Submission – I wish to lodge an objection to SSD-82639959, Precinct 75 Mixed Use Development.

SSD-82639959 seeks to amend/replace DA2021/0799 and DA2021/0800 to:

Figure 2 - Drawing DA-30-02 North-West Elevations from the approved DA2021/0800 – LEP height limits in dotted blue lines.

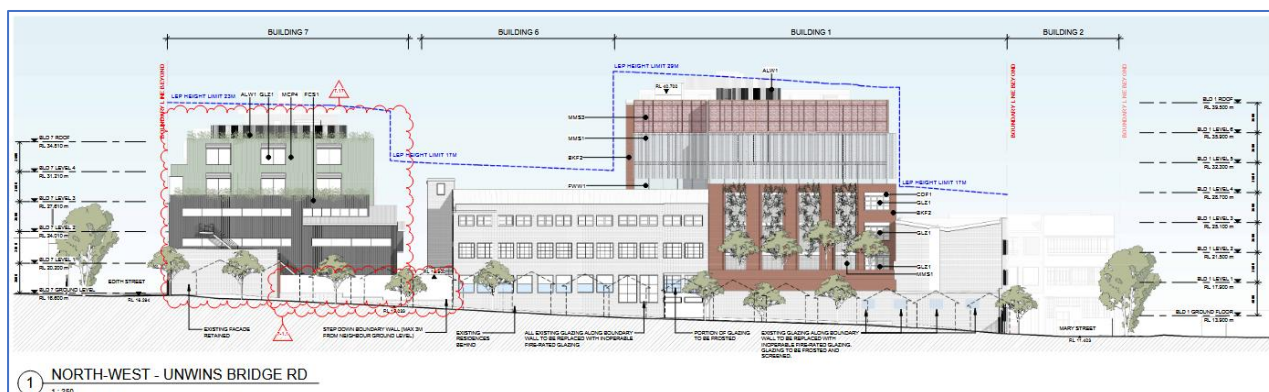
- In **Figure 3**, the Unwins Bridge Road Elevations do not clearly show our homes in the foreground; in the earlier drawings associated with DA2021/0800, refer **Figure 2**, our homes were depicted as dotted lines enabling the reviewer to quickly judge the height, scale and impact of the development by comparing it against the yardstick of their own home or known landmark. **Figure 3**, Unwins Bridge Road Elevation, leads the reader to assume the new 10 storey building has no impact on the surrounding neighbourhood. Note how Building 6 is increasing in height to merge with Building 1. The megastructure will dominate the surrounding neighbourhood, there is no transition in scale. As shown in Figure 2, Under the current LEP, Building 6 has a height restriction of 17metres.

1. With reference to Building 1, removal of vertical garden, planter boxes at levels 4 and 6, and the green roof features that offered full visual privacy, ameliorated the view, was aesthetically pleasing, softened the masonry façade, reduced the impact of scale, bulk, massing, and overbearing effects on neighbouring properties. Reduced reflection from the glazing. Provided cooling effects to the North-West facing façade. **Refer Figure 4 below and Figure 2 above.**

2. Removal of the perforated angled louvre screens from the windows on Building 1 that were specially designed to offer visual privacy for Unwins Bridge Road residents, prevented overlooking, provided shading to occupants, acted as a trellis for the vertical garden. Combined with the vertical garden above, provided additional cooling effects for occupants. Refer **Figure 2 & 4** (Detail) above

3. Removal of the perforated folded screen system from the top floors of many of the buildings on site, this design feature offered shading, cooling, privacy for residents of Unwins Bridge Road and the occupants in the commercial buildings, reduced reflection from glazing and dampened the glow of internal lighting at night. It makes the façade interesting and visually appealing. Refer **Figure 2 & Figure 4** (Detail) above.

5. The increase in height of Building 1 and 6, and other buildings on-site have only magnified the well documented issues of height, bulk, massing, over shadowing, overlooking, overbearing effects, loss of residential amenity, loss of visual and acoustic privacy. Under the current LEP, the height limit on Building 6 is 17 metres. For comparison, please refer **Figure 2** and **Figure 3** above.

Figure 3 – Drawing DA-30-02 North-West Elevations Rev 8, SSD-82639959, Proposed Design - Building 1 at the centre, renamed Building 6

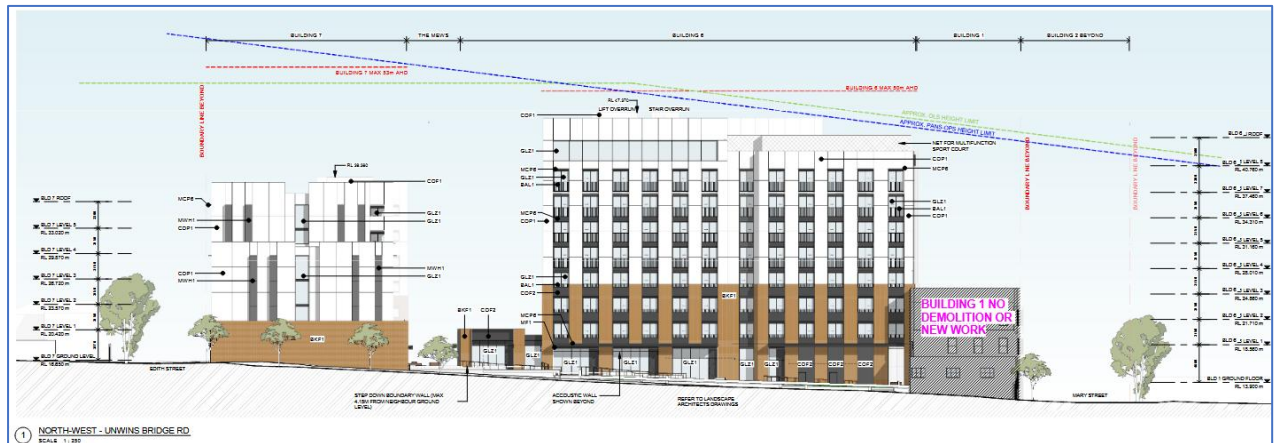
6. Airport Operations, from my review of the site drawings, in particular the Elevations, building heights and AHD levels (appearing as dotted red lines), it is my observation that the new building heights appear to exceed the **45m** (AHD) limit mentioned in extract from the Land & Environment Court Judgement (see below). In SSD-82639959, the top of the plant on Building C is shown as 50m (AHD) and Building 1 (aka 6) and Building 8 are not far off 50m (AHD). Please refer **Figure 3**.

Under DA2021/0800, the windows on the commercial premises of Building 1 & Building 6 were not operable. In Figure 3, and magnified screenshot below, SSD-82639959 indicates the balcony doors are operable, allowing aircraft noise permeate the apartment.

Figure 4 – Building 1 Screen - Detail Section from DA2021/0800

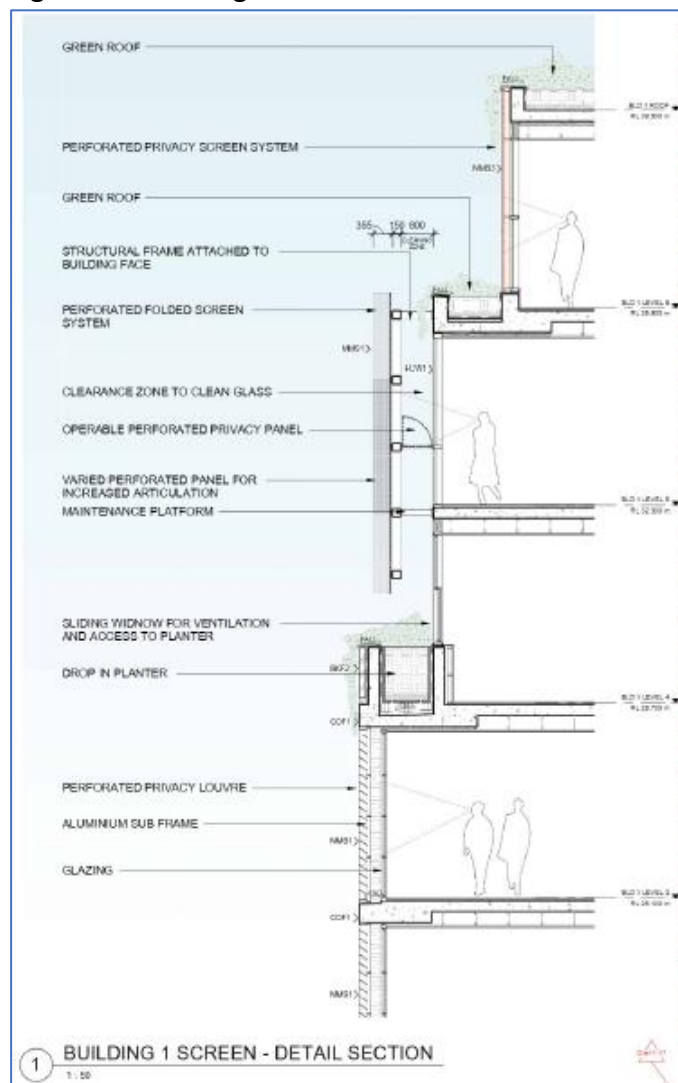
4. Removal of setback on levels 4 and 6 of Building 1, an interesting high quality built form design feature that offered visual privacy, provided transition in scale, prevented overlooking and reduced the overbearing effects. Refer **Figure 4** (Detail) above.

Figure 6 - Screen shots of Level 1 podium with row of screening trees from DA2021/0800

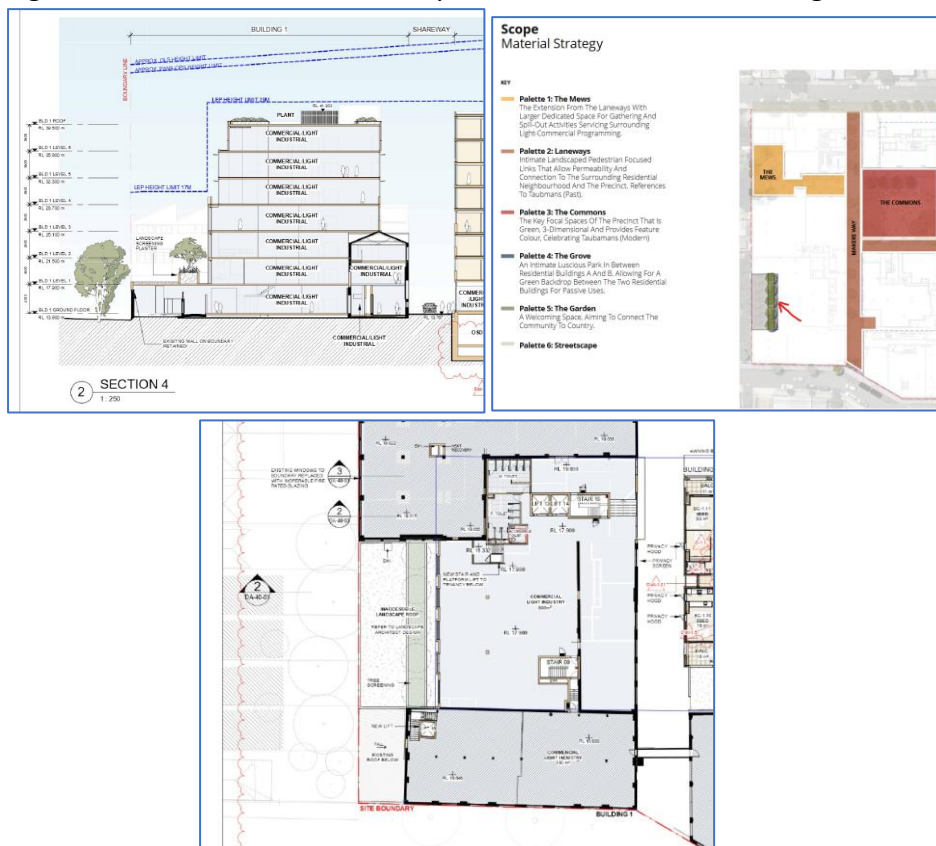
8. Under SSD-82639959 the row of large screening trees along the level 1 podium of Building 1 has been removed. This clever design feature provided additional privacy screening, green views and vista for Unwins Bridge Road residents. Refer **Figure 6**. Because of the podium height RL 17, the screening is much more effective.

Figure 7 – Roof – from DA2021/0800

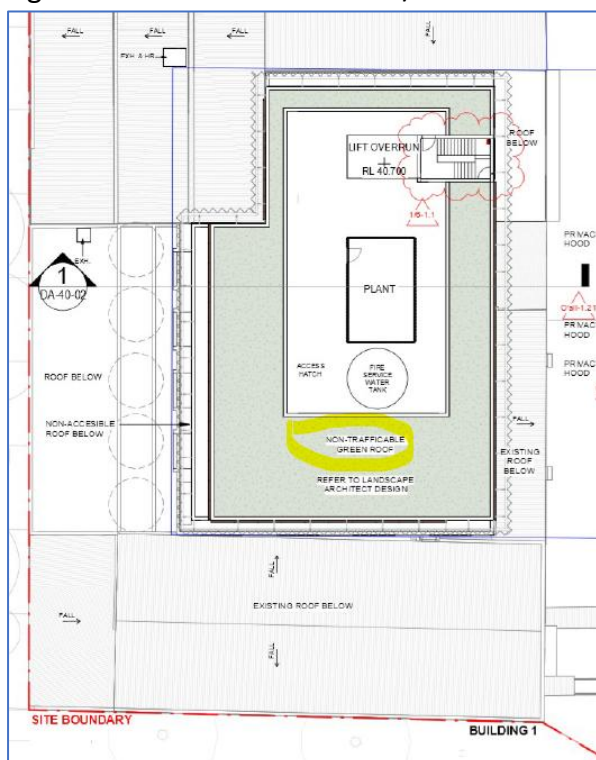
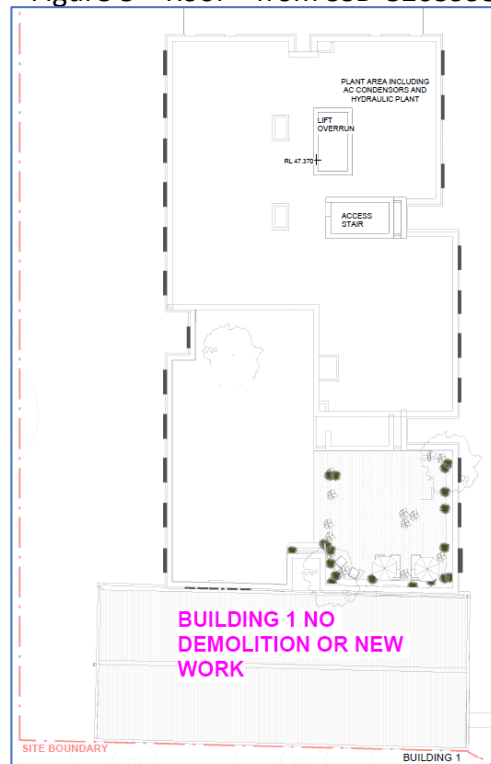
9. Under SSD-82639959 the roof access has been changed from non-trafficable to trafficable and includes a multi-function sport court (refer magnified view) and outdoor amenity.

I can make out umbrellas and chairs. The previous developer added the 'non-accessible' conditions to the roof to prevent the noise from rooftop activity disturbing residents living along Unwins Bridge Road, especially at night. Eg block parties, amplified music, raised voices, social gatherings. **Refer Figure 7 & 8**

Figure 9 – Active Rooftop

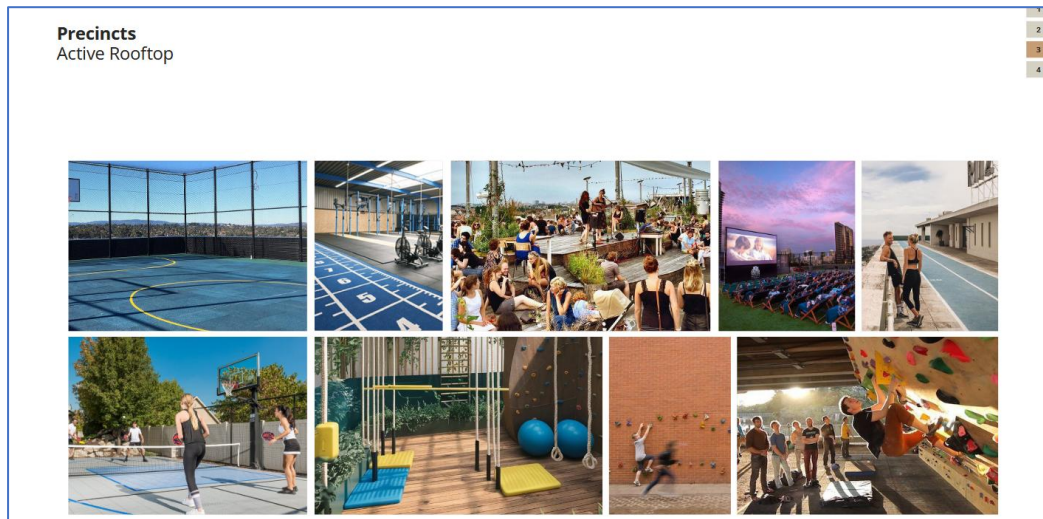
The Landscape DA Package document promotes an Active Rooftop, this confirms the roof will be accessible. The brochure depicts an open sports court, stage with amplified music & outdoor cinema. An active Rooftop is the last thing the resident of St Peters want as we try to sleep at night. This will become a source of community friction. I doubt the Active Rooftop has been factored into the acoustic assessment of the site. **Refer Figure 9**

Figure 10 – Building 6 sight lines on boundary wall and window specifications, DA2021/0800

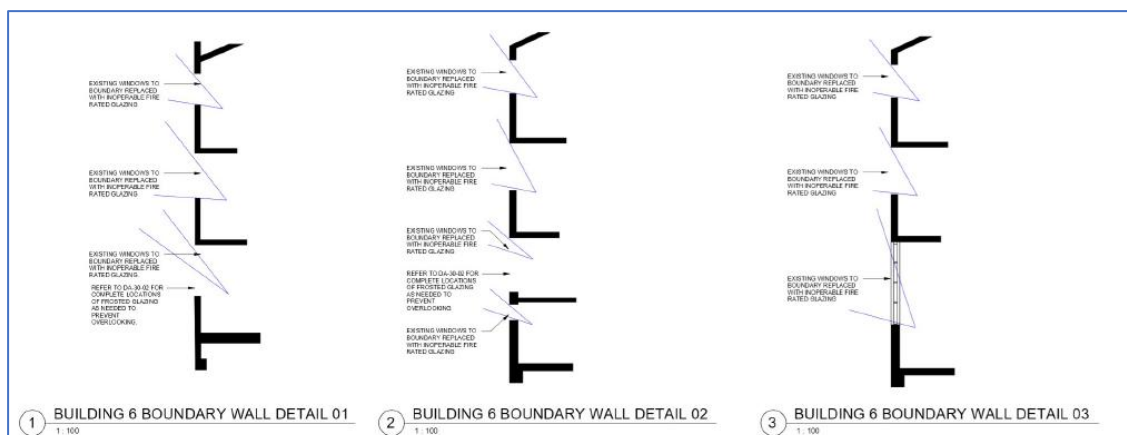
10. Under SSD-82639959, proposed demolition of Building 6 instead of adaptive reuse, loss of an historical building that ties the site to its industrial past. It was a perfect place to house the artist studios. Although built on the property boundary, the positioning and height of the windows in Building 6, provides visual privacy and prevents occupants from overlooking into neighbouring properties along Unwins Bridge Road, **Refer Figure 10 below**. As for acoustic privacy, Annexure B of the court ruling (see below) requires, *‘Existing windows to the boundary to be replaced with inoperable fire rated glazing’*. As stated in point 5 above, the proposed new Building 6 megastructure actually intensifies the overlooking & acoustic privacy problems for residents.

Figure 11 from SSD Landscape DA Package

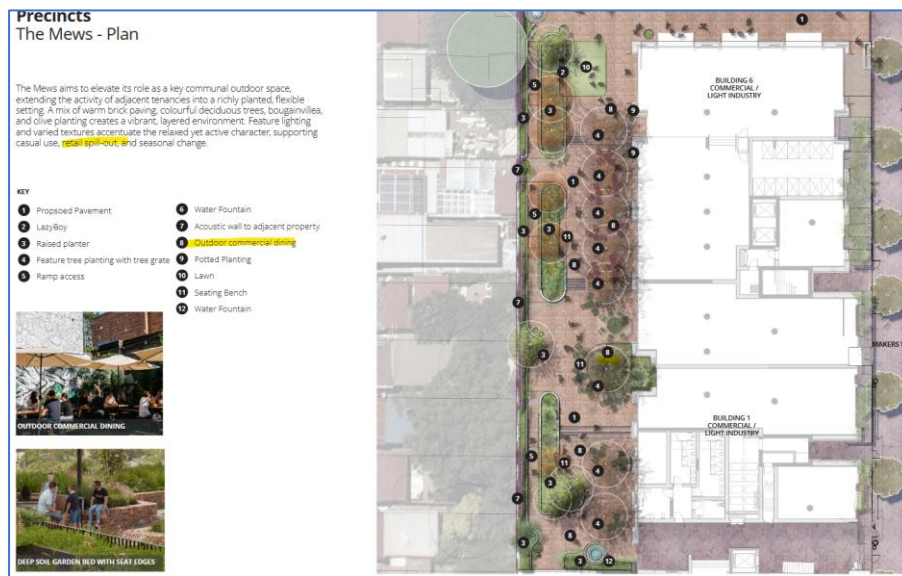
12. SSD-82639959 proposes to demolish Building 1 and Building 6 and as a result create a commercial outdoor corridor area known as The Mews. This design change tells me that the designers haven't read the DCP and haven't analysed the site and its context. Whereas under DA2021/0800, the outdoor commercial businesses were positioned near the centre of the site and along Makers Way to minimise the impact on neighbours, here we have a design that positions the commercial outdoor dining areas and shop fronts right next to the residential properties along Unwins Bridge Road. **Refer Figure 11 below.** Discussions in the Land and Environment Court raised problems associated with outdoor dining and the need for acoustic assessment.
